APPLICATION NO.	FILING DATE	FIRST NAMED INVENTOR	ATTORNEY DOCKET NO.	CONFIRMATION NO.
10/776,176	02/12/2004	Michel Couture	16626-2us PTN/df	3079

Office Action Summary	Application No.	Applicant(s)	
	10/776,176	COUTURE, MICHEL	
	Examiner	Art Unit	
	Mark Hageman	3653

DETAILED ACTION

Fig 1

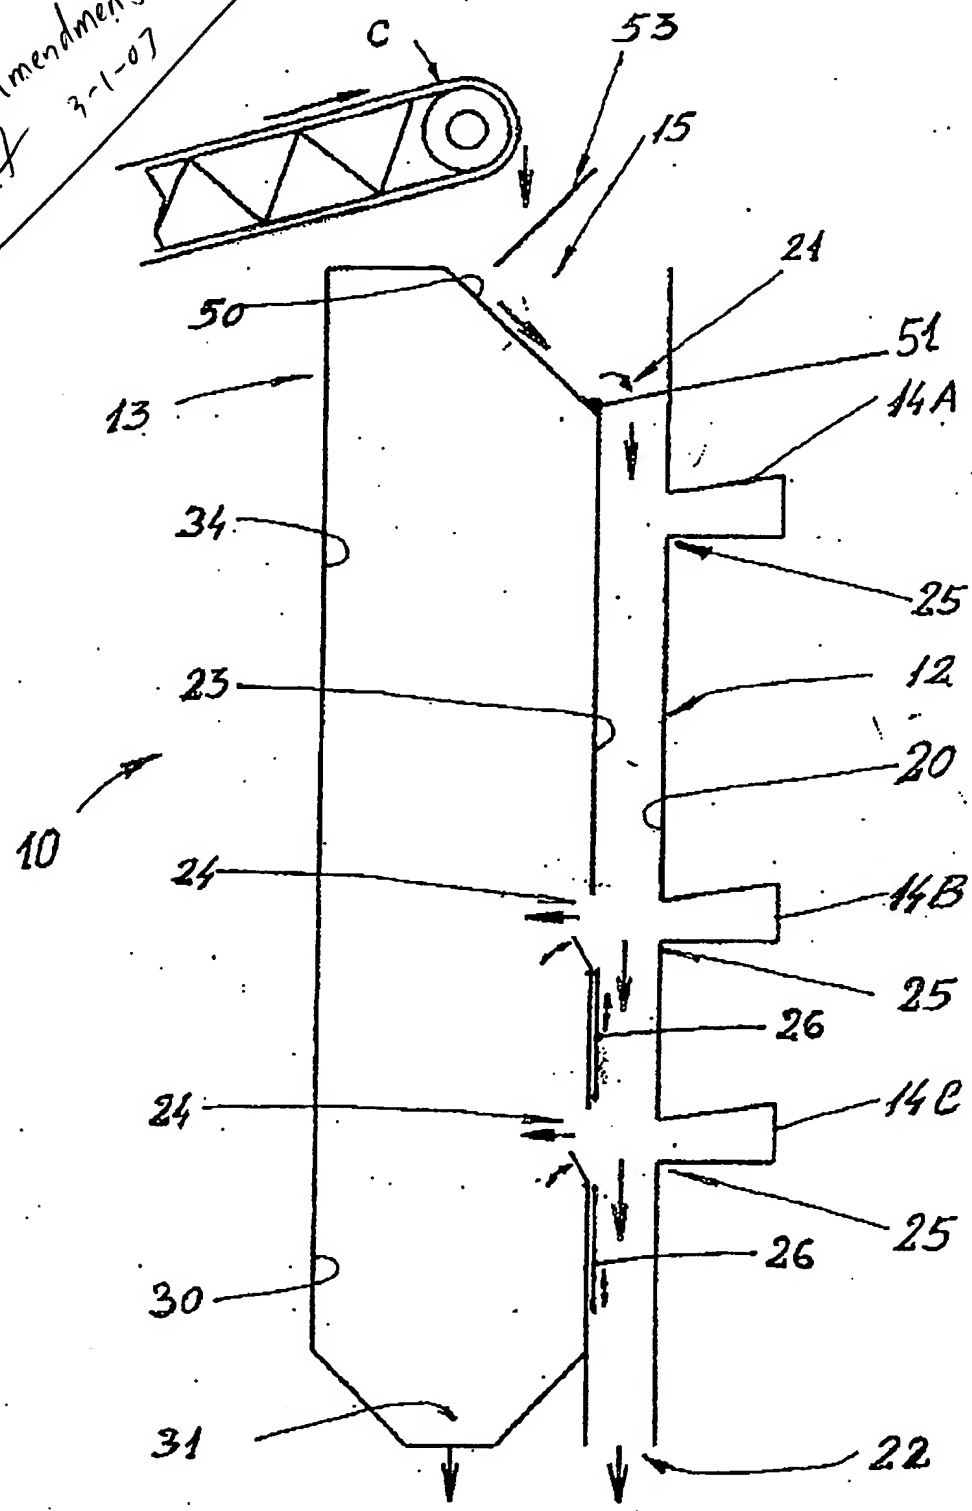
2. The drawing amendment filed 2-22-2007 has not been entered as it introduces new matter. Specifically figure 11 adds structure not supported by the original specification. Examiner acknowledges paragraph 39 as set forth by the applicant regarding figure 11 but maintains that figure 11 includes structure that was not supported by the original specification. Details are present in proposed figure 11 that were not presented in the original specification.

All newly submitted paragraphs along with most of the amended original paragraphs contain new matter, including drawing figure 11. The amendment seeks to change some of the language of the specification and further describe the structure and functioning of the invention. Many of the details presented are not supported by the original disclosure.

Please do
not enter
drawing amendment
MCH 3-1-07

Applicant is required to cancel the new matter in the reply to this Office Action.
